Amended Version 28th February 2023.

Notified changes shown in red text, post-notification ecology changes shown in blue text, post-notification other changes shown in green text.

Appendix S10 - Airport Business Zone Structure Plan

(Additions in underline, deletions in strikethrough)

Airport Business Zone Structure Plan
Appendix S10

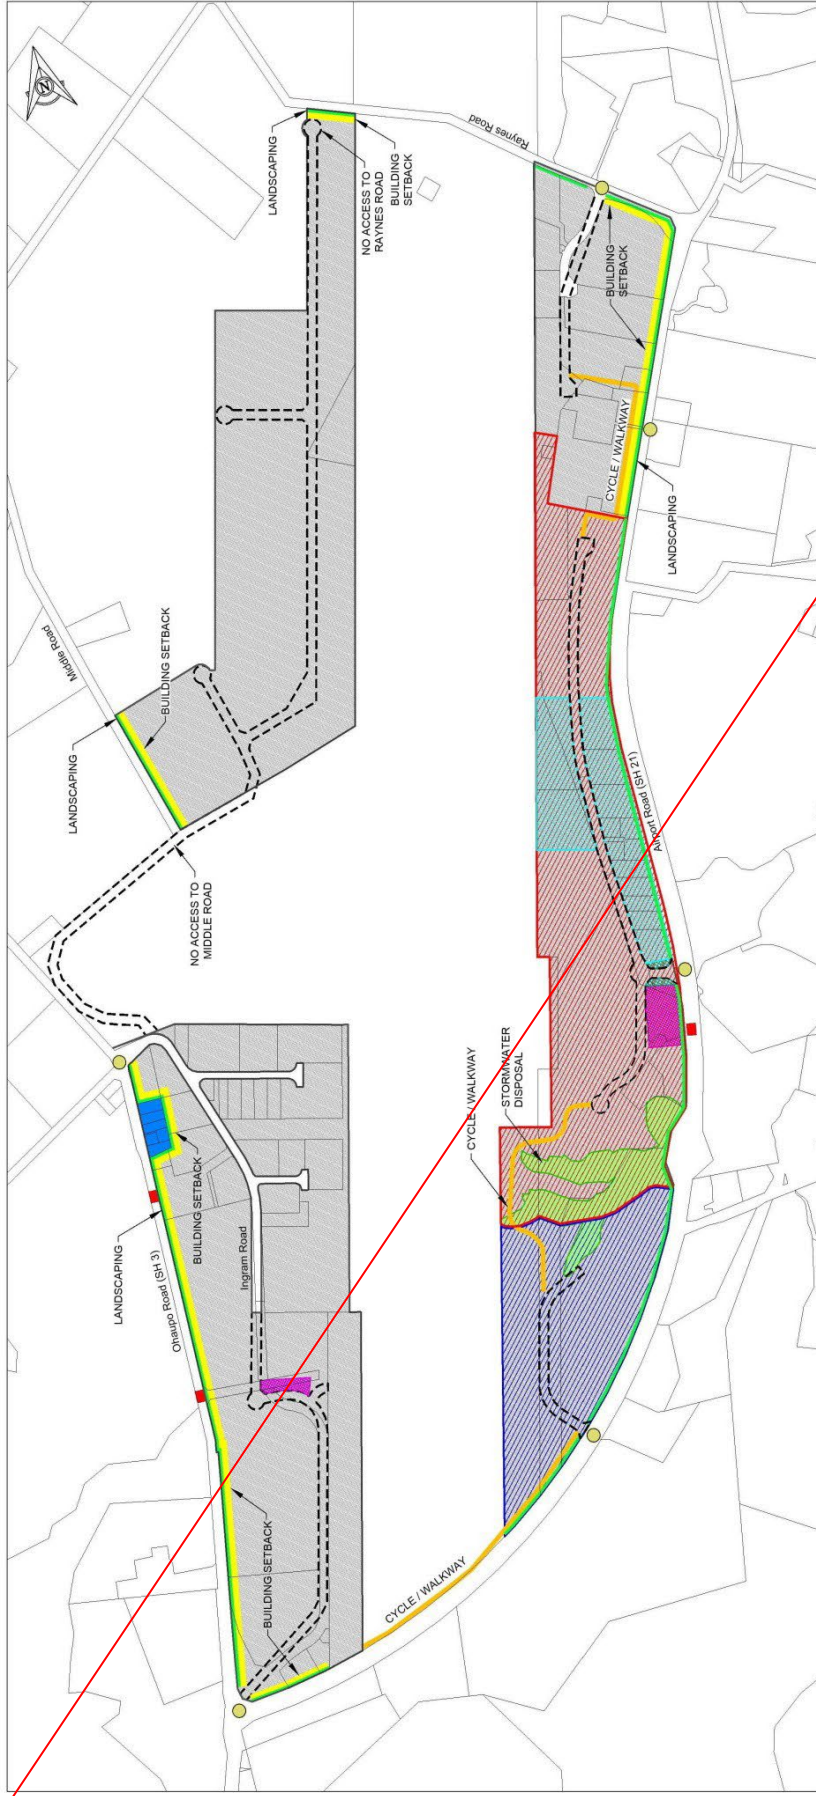
S10.2.1 A ~~40ha~~ 130ha area of land to the northwest of the airport adjacent to the main runway known as the Northern Precinct has been identified for expansion of the business park. ~~A master planning approach has also been applied to this land so the principles in S10.3 (where relevant) will apply to it.~~

S10.2.2 There will be no direct vehicle access from lots or activities within the Northern Precinct land to Narrows Road, Raynes Road, or any section of Middle Road that does not have Airport Business zoned land on both sides ~~and vehicle access will be by way of an internal road connection to the Western Precinct.~~

S10.2.3 Access will be achieved through intersections onto State Highway 3 (SH3) and Raynes Road while protecting the ability to establish a direct connection to the future Southern Links Central interchange when it is constructed.

FIG 1 Bat Habitat Areas (Corridor) - Typical Cross Section @ 1:500 - A4

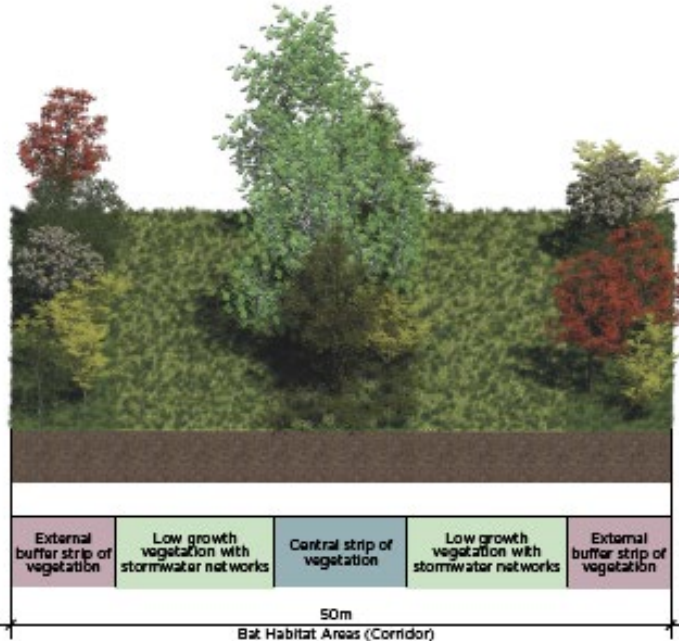
- S10.3.13 For the Northern Precinct, the areas which are identified as Bat Habitat Areas are to be protected and enhanced as bat habitat. Enhancement of the corridor which forms part of the Bat Habitat Areas will occur in general accordance with Figures 1 and 2. Multi-functional use of the Bat Habitat Areas involving stormwater networks is anticipated and provided for to enable efficient use of the land where the activities do not adversely affect use of the areas by long-tailed bats to a more than minor extent.
